UNITED STATES PATENT AND TRADEMARK OFFICE

APPLICATION NO.	FILING DATE	FIRST NAMED INVENTOR	ATTORNEY DOCKET NO.	CONFIRMATION NO.
09/484,421	01/18/2000	Martin Dubs	622/48561	9681

Office Action Summary	Application No. 09/484,421	Applicant(s) DUBS ET AL.	
	Examiner Gregg Cantelmo	Art Unit 1753

DETAILED ACTION

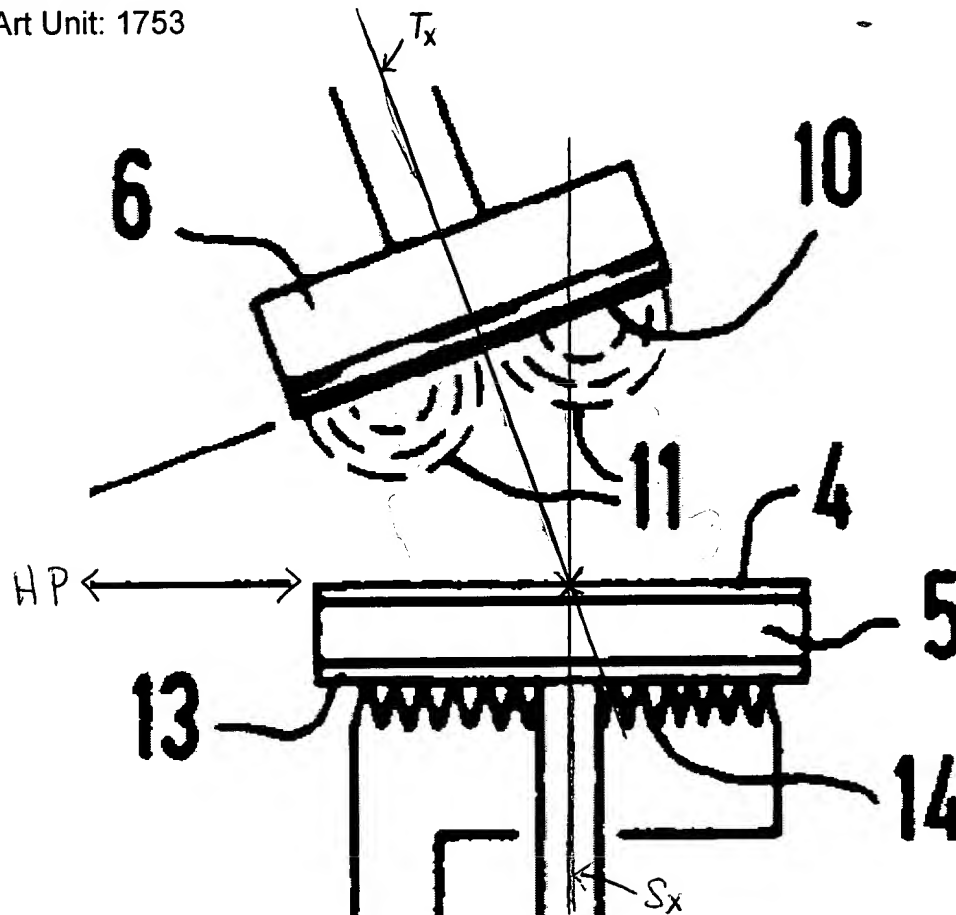
Fig. 1 discloses a sputtering chamber 3 comprising at least one sputtering source 6 with a new sputter surface 10 at least approximately symmetrical with respect to a first axis (Tx) (see drawing below for details), the axis being perpendicular to the sputter surface 10, substrate carrier 3 which is arranged to be driveably rotatable about a second axis (Sx), wherein the first and second axes are oblique with respect to one another and said sputtering source is a magnetron sputtering source with at least one toroidal magnetic field 11 around said first axis with symmetric field polarity considered in a cutting plane through said new sputter surface and containing said first axis (as applied to claim 35).

The first and second axes are virtual and infinite along the plane which defines each respective axis. Since the axes are oblique, they will intersect at some point (red X in marked up Fig. 1 above as applied to claim 37).

The substrate carrier 13 is located within chamber 3 at least approximately horizontally (HP in marked up Fig. 1 above as applied to claim 43).

The substrate carrier surface and new sputter surface bound a process space as shown in Fig. 1 (yellow highlight as applied to claim 57).

Fig. 12 PRIOR ART

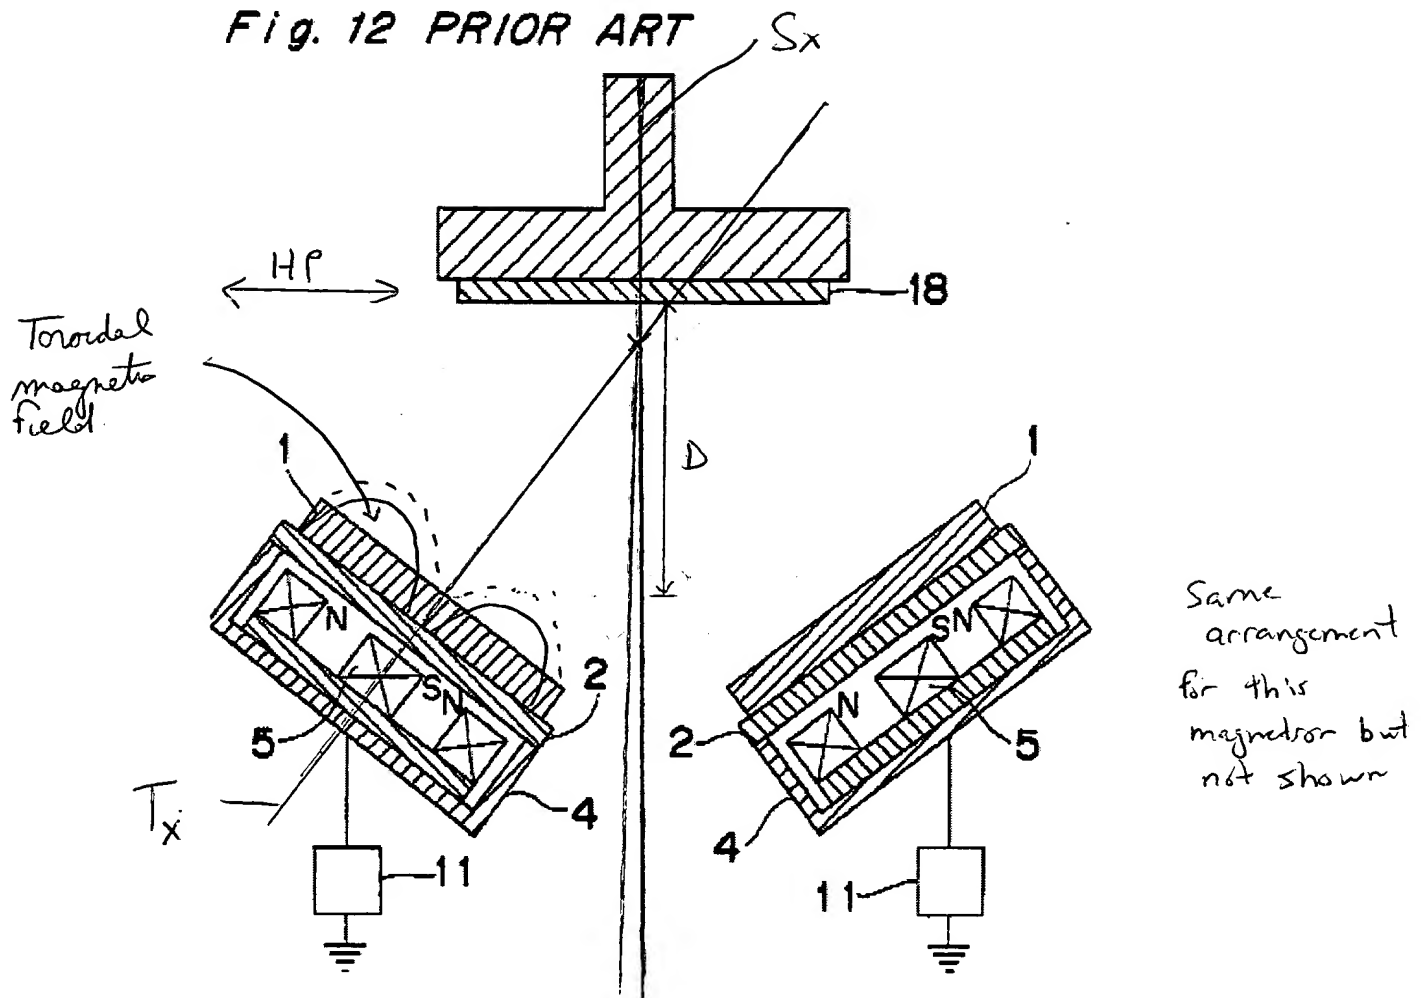
Fig. 12 shows a prior art configuration which read on the following claims: a sputtering chamber (not shown in Fig. 12 but inherent to a sputtering system, see Figs. 7 and 11 which show placement of sputtering equipment in a sputtering chamber

comprising at least one sputtering surface symmetrical with respect to a central axis (central axis Tx as marked up below) the axis perpendicular on said new sputtering surface, a substrate carrier (carrying substrate 18) having a second axis (Sx as marked up below) the two axes are oblique with respect to one another, and said sputtering source is a magnetron sputtering source wherein the magnet polarities are arranged such that they will generate a toroidal magnetic field around the first axis with symmetric field polarity considered in a cutting plane through the new sputter surface and containing said first axis. The field lines have been drawn in by the Examiner (dotted lines) given the location of each pole in the target, a toroidal field will result (see also col. 1, ll. 58-60 as applied to claim 35).

The first and second axes are virtual and infinite along the plane which defines each respective axis. Since the axes are oblique, they will intersect at some point (see red X in marked up Fig. 12 below as applied to claim 37).

Two sputtering surfaces 1 having individual power sources 11 are provided in the system shown in Fig. 12 (as applied to claim 45).

The surface of the substrate 18 and its carrier and the surface of the sputter surfaces 1 bound a process space on two sides (yellow highlight Fig. 12 as applied to claim 57).

The prior art employs a method for coating workpiece 18 comprising: introducing workpiece 18 into the sputtering chamber, providing a sputtering source 1 with a sputtering surface and having a central axis which is oblique with respect to the axis of the substrate carrier, sputter coating the workpiece by the source where the source has a toroidal magnetic field with a symmetric field-polarity considered in a cutting plane through said sputter source which contains the normal axis (the toroidal magnetic field lines inherent to the magnetrons in Fig. 12 given the polarities of the electromagnets shown in the magnetrons as applied to claim 58).

The magnetrons are shown to be at an angle relative to the substrate carrier and although the prior art disclosure of Yamanishi does not explicitly disclose of the range, from a comparison of the position of the magnetrons relative to the substrate as shown in Fig. 12 to that of (Figs. 2 and 7) it would appear that the range of angles for positioning the magnetron sources would have been identical. The preferred angle of the invention of Yamanishi is between 30° and 60° (col. 3, ll. 21-25) to provide uniform thickness of the film on the substrate (col. 8, ll. 25-28 as applied to claims 38-41). And by one example the actual angle is 45° (col. 7, ll. 17-24). Thus it would have been
